## **TRANSPORT IMPACT ASSESSMENT**

### **PROPOSED WAREHOUSE DEVELOPMENT**

1 HIGHLAND STREET, STAPYLTON QLD 4207

(RESPONSE TO INFORMATION REQUEST DATED 7 AUGUST 2026)

FIGURE 3.2 – PROPOSED CONCEPT PLAN OF ADDITIONAL OFF-STREET PARKING

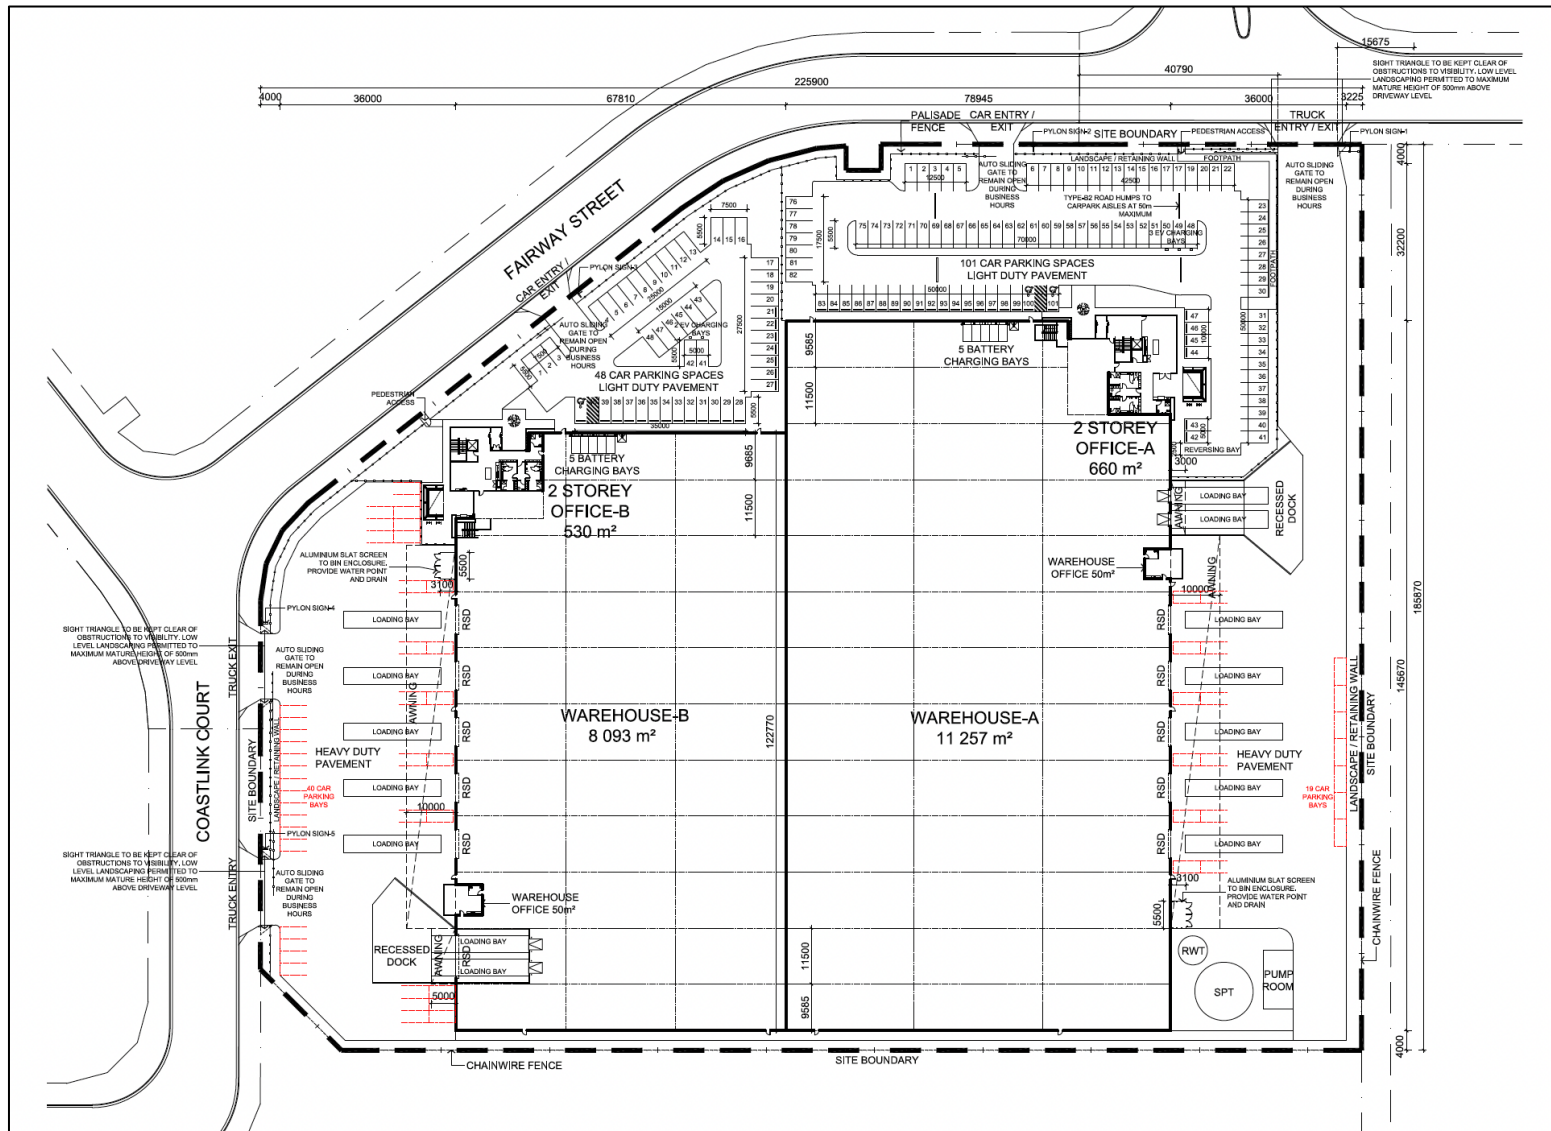
*To comply with AS8.1.1 and AS8.1.2 of the M38 Industrial Estate Place Code, the development must be provided with a total of 120 spaces for Warehouse A and 88 spaces for Warehouse B. The submitted drawings show 101 spaces for Warehouse A and 48 spaces for Warehouse B. Rytenskild Traffic Engineering has advised that tenant for each Warehouse is yet to be confirmed but anticipates that the provided parking supply will accommodate the expected parking demand.*

*Officers accept the car parking demand associated with Warehouse development is less than other industrial development. The applicant is requested to provide further justification to substantiate the proposed shortfall of car parking. Specifically, as has been sought in previous applications within this industrial estate, the applicant is requested to provide indicative concept plans identifying where additional off-street car parking demand could be accommodated on proposed hardstand areas should the use of tenancy be converted into a separate industrial land use. This concept plan is not intended to be an 'approved drawing' for endorsement; rather, part of the common material to substantiate the proposed shortfall of off-street car parking and to demonstrate flexible use of the premises for intended industrial development in future.*

The development provides 101 car parking spaces for Warehouse A and 48 spaces for Warehouse B, compared with the Acceptable Solution requirements of 120 spaces and 88 spaces respectively.

The reduced parking provision is considered satisfactory having regard to the proposed warehouse use and the observed parking utilisation of comparable warehouse developments within the surrounding industrial area.

An indicative concept plan has also been prepared demonstrating how the full numerical parking requirement could be accommodated on-site if required in the future. As shown in Figure 3.2, an additional 19 spaces for Warehouse A and 40 spaces for Warehouse B can be accommodated within the respective hardstand areas.

This would increase the total potential provision to 120 spaces for Warehouse A and 88 spaces for Warehouse B, consistent with the applicable Acceptable Solution.

The additional parking does not form part of the proposed operational layout but demonstrates that the site retains sufficient flexibility to accommodate the full numerical parking provision should the nature or intensity of the warehouse uses change in the future.

In addition, Figure 3.2 demonstrates that the site has sufficient flexibility to accommodate the full numerical parking requirement if required in the future. An additional 19 spaces can be accommodated within the Warehouse A hardstand and an additional 40 spaces within the Warehouse B hardstand, providing potential totals of 120 and 88 spaces respectively.

The concept parking does not form part of the current operational arrangement and would replace portions of the heavy vehicle hardstand if implemented. It nevertheless demonstrates that additional off-street parking can be accommodated on-site should the operational characteristics or intensity of the development change.

FIGURE 5.5 – ACCESS ARRANGEMENTS (HEAVY VEHICLE CROSSOVER – WAREHOUSE A)

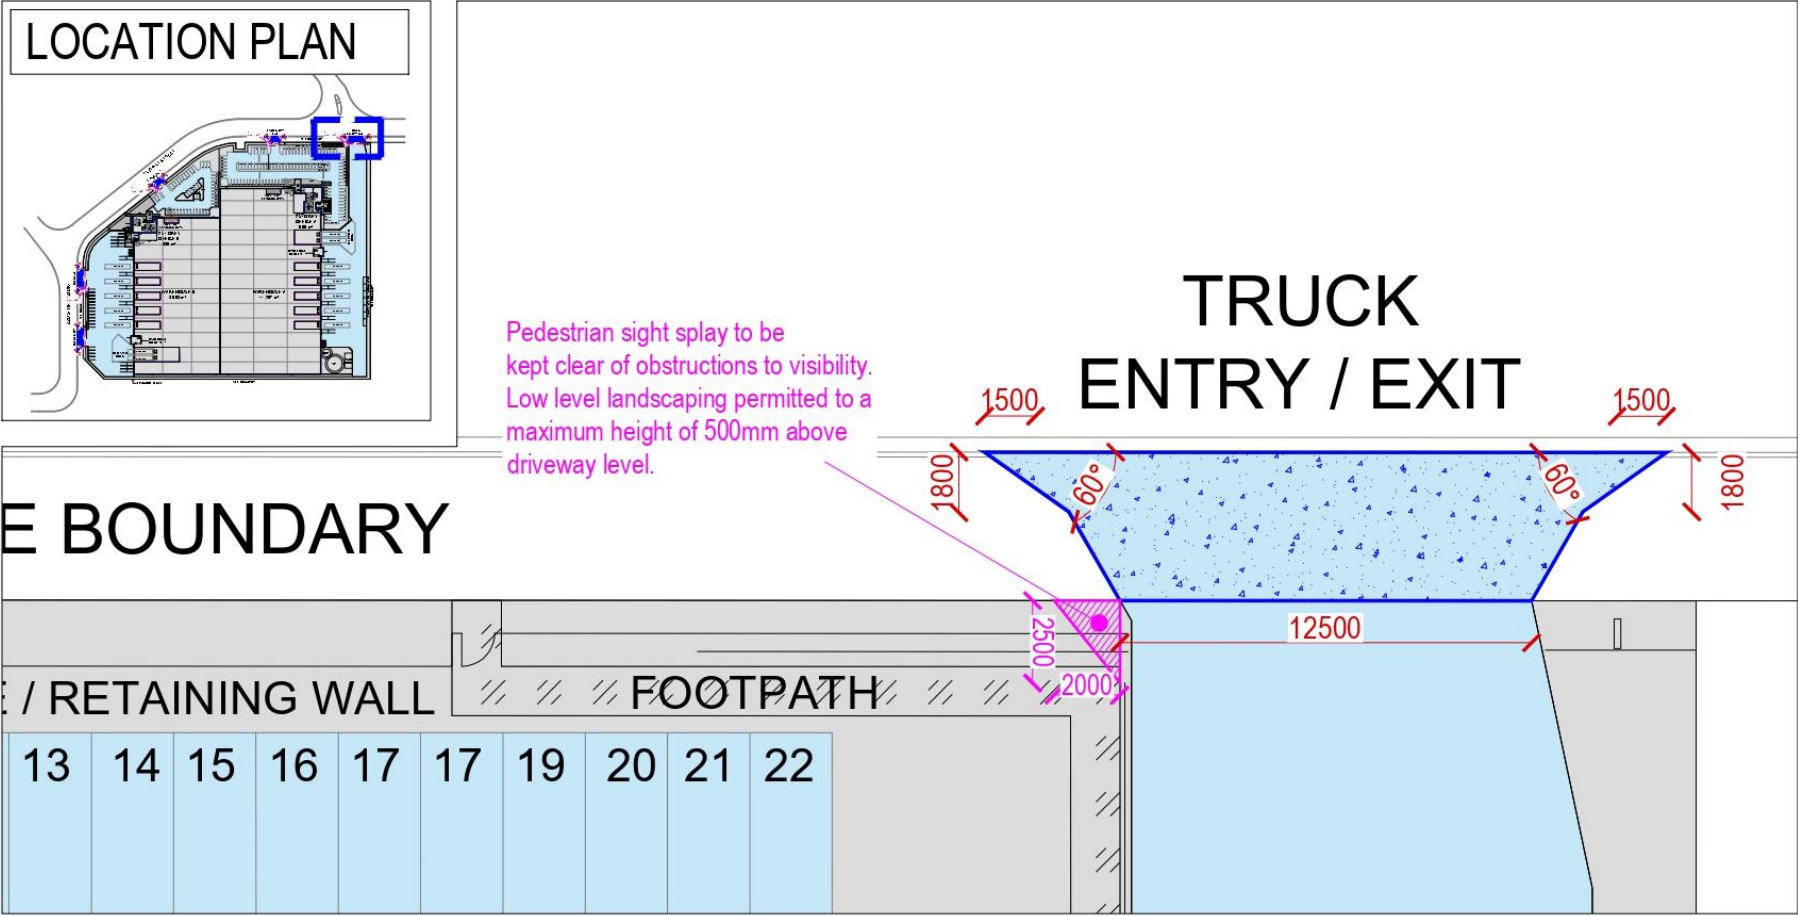
*Architectural plans, "Site Plan, Q25-001A-DA-003, revision B" dated 01.07.2026 prepared by Frasers Property reflects Truck entry/exit vehicle crossing for warehouse A at North-East fronting Fairway street is located directly fronting T-intersection. Specifically, the location of the vehicle crossing to a public roadway is required to be consistent with AS/NZS 2890.1:2004 Parking facilities Part 1: Off-street car parking and AS 2890.2–2002 Parking facilities Part 2: Off-street commercial vehicle facilities. The applicant is required to provide the distance from the vehicle crossing to the intersection.*

*If the vehicle crossing is proposed to remain directly fronting the T-intersection, an RPEQ traffic engineer is required to assess the risks associated with the proposed crossing location and provide certification confirming that the proposed location is safe and suitable. The relevant certification or supporting letter from the RPEQ traffic engineer is to be submitted to Council for consideration.*

The proposed Warehouse A truck crossover is located at the eastern end of the Fairway Street frontage, opposite the approach lane on Homestead Drive.

As shown in Figure 1a, the intersection is clearly delineated and includes a splitter median island on the Homestead Drive leg. The only drivers using the subject driveway will be professional heavy vehicle drivers who are familiar with the site and access arrangements. A KEEP LEFT sign can be implemented on the nose of the island to reinforce to drivers exiting the site that they need to keep to the left of the island.

- It effectively forms a defined four-way intersection arrangement: The truck crossover is generally aligned with the opposing intersection leg, effectively forming a fourth leg to the existing intersection rather than creating a separate access immediately adjacent to it.
- Avoids an offset access arrangement: Relocating the crossover further west would create a closely spaced, offset access near the intersection, introducing an additional conflict point and requiring heavy vehicle turning movements in close proximity to the intersection.
- Provides satisfactory visibility and geometry: The crossover is located on a clear section of the frontage and provides suitable geometry for the anticipated heavy vehicle movements. Swept path analysis demonstrates satisfactory access and manoeuvring.

Overall, the proposed truck crossover location is considered to provide a safe and practical access arrangement. The alignment with the opposing road leg provides a more conventional and legible intersection arrangement than a closely spaced offset crossover and is considered satisfactory from a traffic engineering perspective.

The Warehouse A truck crossover at the eastern end of Fairway Street is located generally opposite the adjoining road intersection. The eastern edge of the crossover is approximately 15.675 metres from the tangent point of the intersection, and the crossover has an overall width of approximately 36 metres.

The crossover therefore effectively operates as a fourth leg to the existing intersection. This provides a clear and defined intersection arrangement and avoids creating a separate, closely offset heavy vehicle access immediately adjacent to the intersection.

The proposed location is considered preferable from a traffic engineering perspective, as it consolidates vehicle conflict points within the intersection environment rather than introducing an additional offset conflict point.
